**BEFORE AN INDEPENDENT HEARINGS PANEL
IN CHRISTCHURCH**

IN THE MATTER OF of the hearing of submissions on Plan Change 14
(Housing and Business Choice) to the Christchurch
District Plan

**STATEMENT OF REBUTTAL EVIDENCE OF ROBERT BRIAN NORTON ON
BEHALF OF CHRISTCHURCH CITY COUNCIL**

STORMWATER AND FLOODING

Figure 1 – Summerset Cavendish Site - 137 Cavendish Road

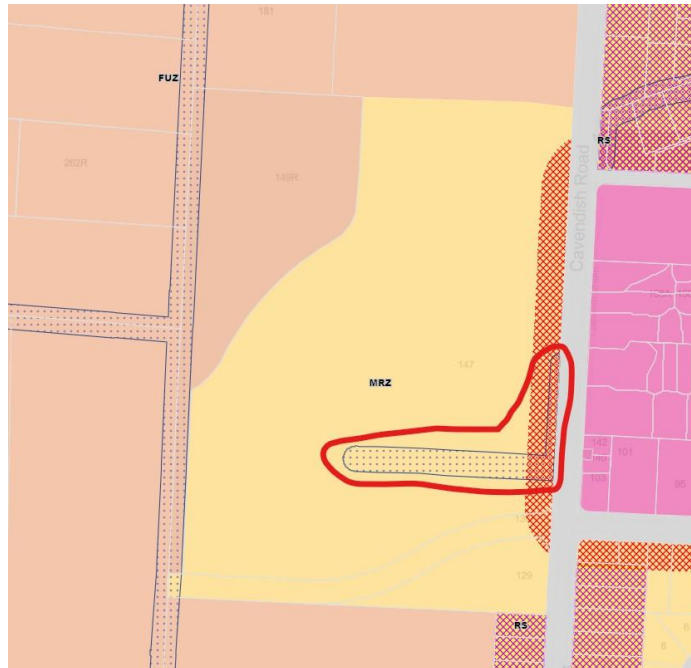
26. I agree with Ms Styles' summary of waterways affecting the Cavendish Village site (her primary evidence paragraphs 7.28 to 7.30). The waterway setback which extends onto the site is related to waterway which has been decommissioned and removed under the consented development process. **This corrects paragraph 82 of my primary evidence.**
27. I recommend that the waterways setback overlay pictured below (Figure 1) on the proposed planning maps be removed.
